**CITY OF KELOWNA  
MEMORANDUM**

**DATE:** June 21, 2007  
**FILE NO.:** DP07-0007/DVP07-0008

**APPLICATION NO.** DP07-0007/DVP07-0008      **OWNER:** Windmill Ventures Ltd.

**PURPOSE:** TO SEEK COUNCIL APPROVAL FOR A DEVELOPMENT PERMIT TO  
CONSTRUCT A 5 STOREY, 41 UNIT MULTIPLE FAMILY  
CONDOMINIUM HOUSING DEVELOPMENT

**BUILDING  
ELEVATIONS**

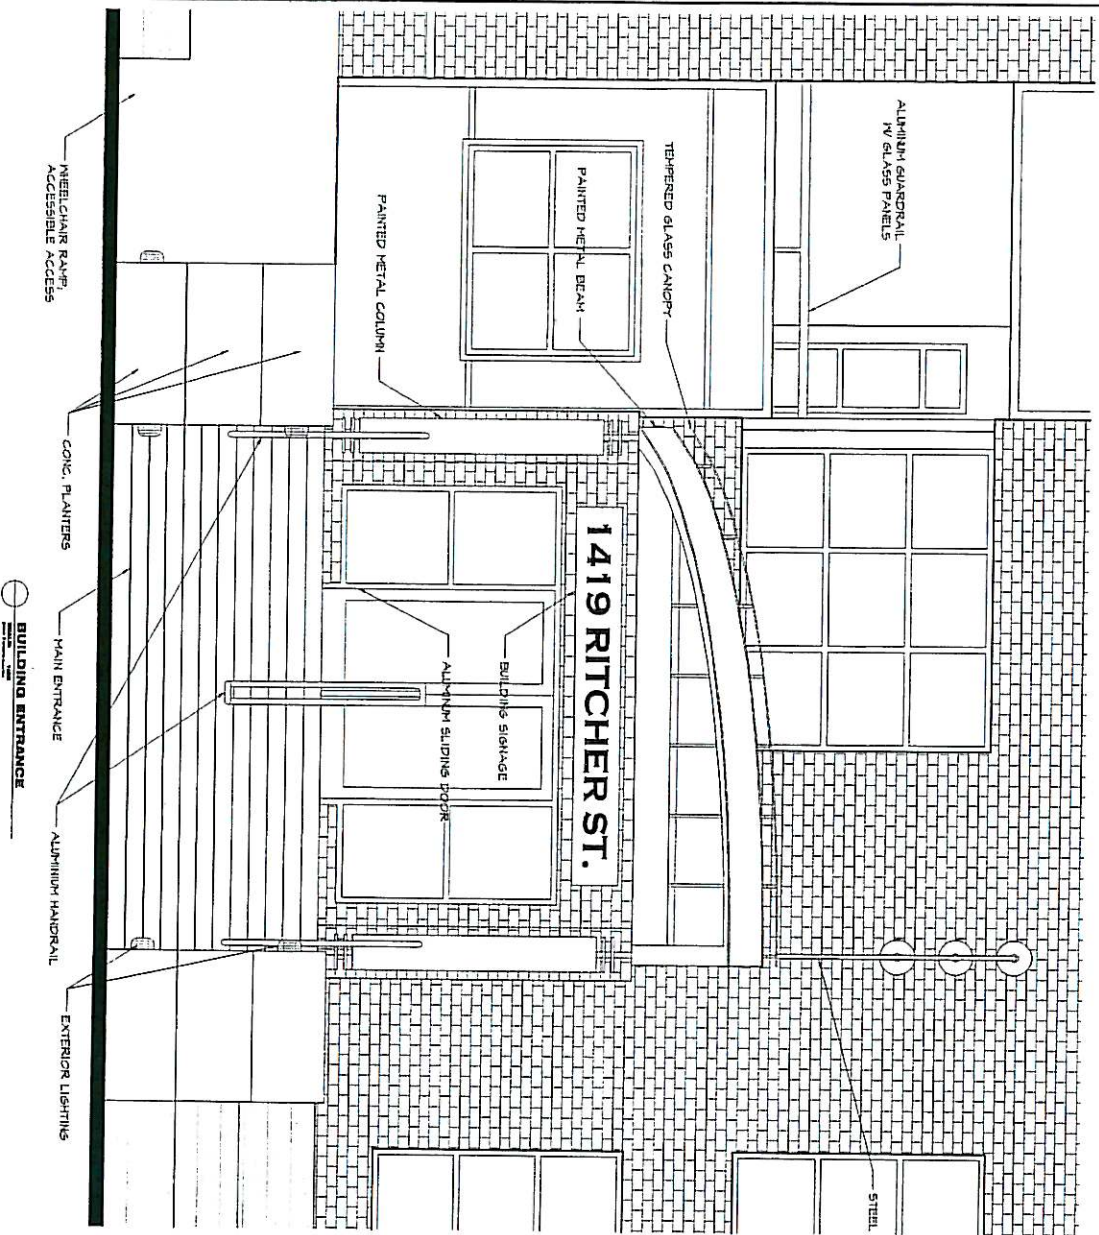
However, to maintain and enhance the level of quality in this development, Staff have offered internal design comments that have resulted in façade improvements on the northeast corner of the building to increase the number of window openings to enhance a level of animation/movement and/or streetscape appeal. For streetscape continuity it has also been suggested to coordinate landscape plantings to compliment the street frontage for a similar project noted as 'Azure' located on Stockwell and Richter Streets.
